From: McKnight, Kevin - DNR
Sent: Friday, September 08, 2017 1:08 PM
To: Kurt McClung (kmcclung@keyengineering.com); David Buck; luke.bergstrom@gmail.com
Cc: McKnight, Kevin - DNR
Subject: Realty Opus/ Valley Road VPLE

I met with the VPLE committee yesterday to discuss this case. Based on the review the Department has the following update:

Red Box - Extent of Cap
 Green Box - Extent of Vapor Barrier (under buildings only)

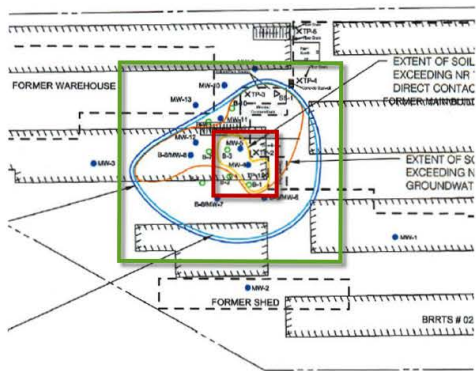
- The soil investigation is complete.
- One (minimum) additional round of groundwater sampling is requested from the following wells for VOC's and PAH's: MW-3, MW-4, MW-5, MW-6, MW-7, MW-8, MW-11, MW-12 and GP17-02. The results of this sample round should be submitted to the Department as soon as possible to allow Department review and hopefully, approval to abandon these wells prior to pouring concrete.
- I have attached a figure with the minimum required extent of capping for direct contact and minimum extent of vapor barrier installation. The department understands that the majority of the site will be paved with asphalt or concrete and vapor barrier installation under all building has already been planned. This figure is for use in developing the cap maintenance plan and case closure documents.
-
